## Memorandum

### Subject: Delmore Development - Geomorphic Response Memo

Vineway Ltd are applying for consent under a fast-track application for a proposed development within the Ōrewa River West catchment.

Figure 1. Stream network and culvert locations.

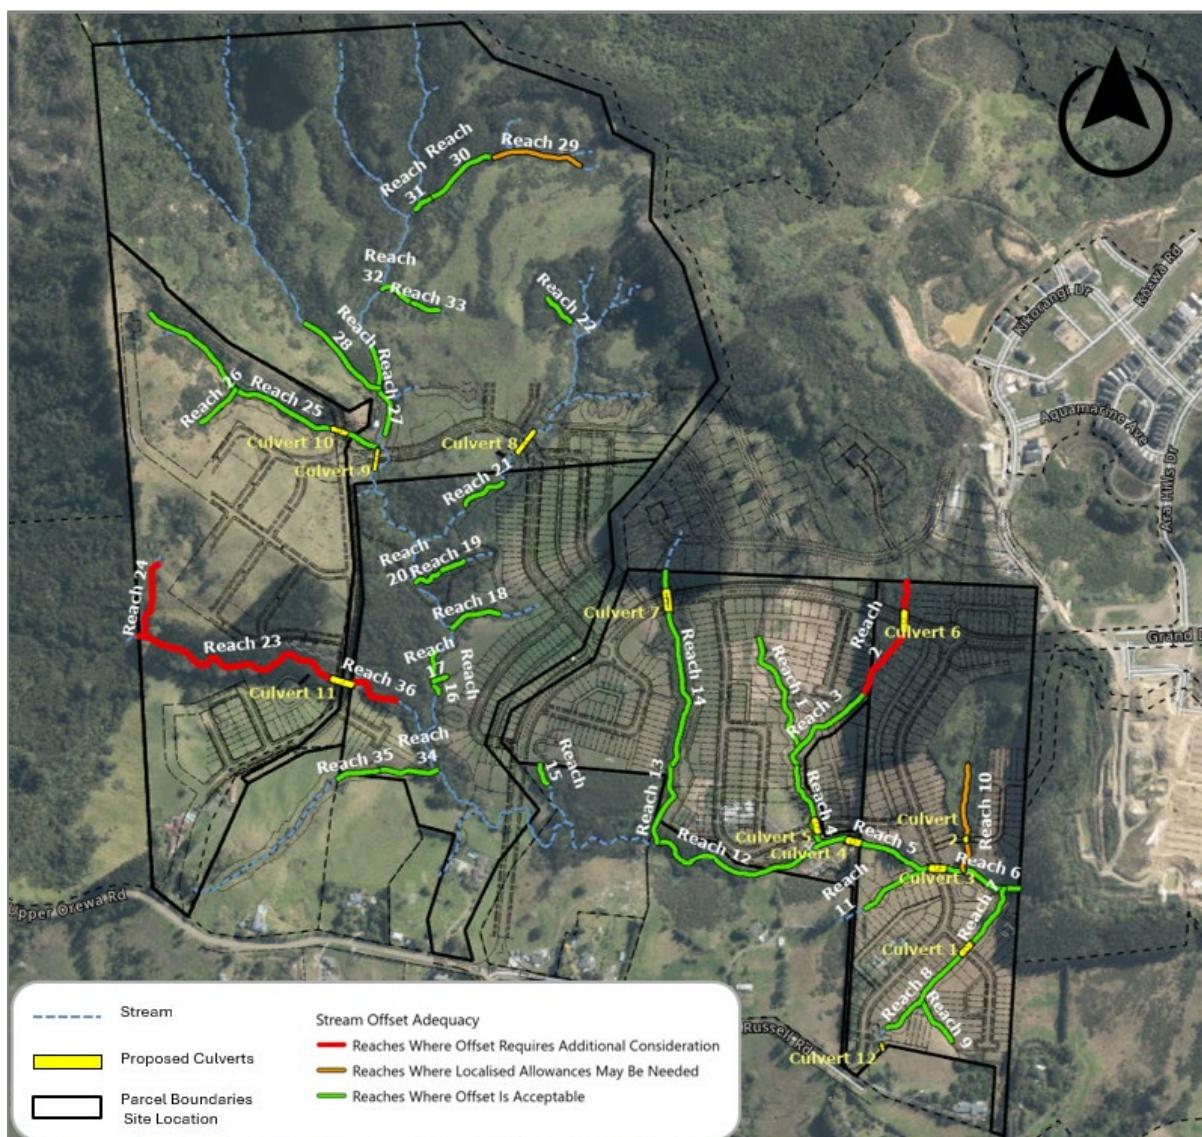
*"Reach 4 – Geomorphic assessment identified that the upstream wetland is sustained by the existing culvert and is sensitive to changes that may create a preferential channel. This is relevant to proposed culvert 5."*

*"Reach 7 – Geomorphic assessment identifies the risk of upstream migration and culvert undermining. This is relevant to culvert 1."*

*"Reach 17 – Geomorphic assessment finds that this reach is incising. There is the potential for upstream incision to continue. This is relevant to wetlands associated with proposed culvert 7."*

*"Reach 27 and 28 - Potential for channelisation if and loss of wetland if stormwater regime changes. This is relevant to proposed culverts 9 and 10."*

The Geomorphic Risk Assessment identified Reach 4 as an incised reach where the upstream wetland (Reach 3) is sustained by an existing culvert and associated bunding. The assessment noted that this wetland is sensitive to changes that may create a preferential channel, particularly if the existing culvert were removed.

The proposed Culvert 5 is located further downstream of the wetland area. Based on its location, no direct impact on the upstream wetland is anticipated.

The geomorphic sensitivity identified in the assessment primarily relates to the existing farm culvert near the Reach 3/4 boundary. If this culvert is removed or modified, it is important that the hydrological conditions created by the existing culvert and downstream bunding are maintained, including allowance for upstream ponding and protection of the stream bed currently provided by the culvert structure.

Where these conditions are maintained, based on the current design information, the risk of wetland channelisation identified in the Geomorphic Risk Assessment is expected to be low.

Reach 7 was identified in the Geomorphic Risk Assessment as a transition from an incised to a non-incised channel. Knickpoints were identified in the approximate location of the culvert (and will effectively be removed as part of culvert construction) and downstream of the culvert. Under existing conditions, the knickpoint is expected to migrate upstream, however, the rate of upstream migration is unknown..

The proposed culvert in this reach is embedded, and post-development velocities are similar to pre-development conditions. On this basis, the culvert is not expected to exacerbate the existing knickpoint migration process.

Knickpoint migration within this reach is recognised as a natural geomorphic process. Ongoing monitoring is recommended as part of stormwater management, with remediation to be undertaken if upstream knickpoint migration is at risk of undermining the road culvert. The proposed culvert design does not introduce additional drivers that would accelerate this process beyond existing conditions.

The Geomorphic Risk Assessment identified Reach 17 as an incising reach, reflecting an ongoing natural geomorphic process. This condition was considered in the assessment, and the associated offset was classified as acceptable.

This reach does not include wetlands or proposed culverts. Accordingly, no specific culvert-related geomorphic concerns have been identified for this reach.

Culvert 7 is associated with Reach 14. The Geomorphic Risk Assessment identified this area as having moderate instability, with a valley-bottom setting that includes wetland areas and sections of defined channel. Previous geomorphic advice relating to potential stream incision was provided to the geotechnical team and has since been incorporated into the updated stability modelling for this reach.<sup>3</sup>

Based on the location of the proposed Culvert 7 in relation to Stream 14, no specific geomorphic concerns have been identified in relation to the culvert itself. The proposed culvert includes embedment and is associated with post-development outlet velocities that are lower than existing conditions. As a result, channel grade is expected to be maintained, and no increase in erosion or wetland channelisation risk is anticipated relative to the pre-development scenario.

Reaches 27 and 28 were identified in the Geomorphic Risk Assessment as wetland systems with potential for channelisation if the stormwater regime were to change. The geomorphic recommendation for these reaches is to maintain a low-energy wetland environment.

The proposed culverts (9 and 10) are embedded and are associated with reduced post-development velocities compared to existing conditions. On this basis, no increase in geomorphic risk to the wetlands is anticipated from the proposed culverts. Maintaining the hydrological conditions created by the existing downstream culvert and bunding arrangements remains important to preserving wetland function and stability.
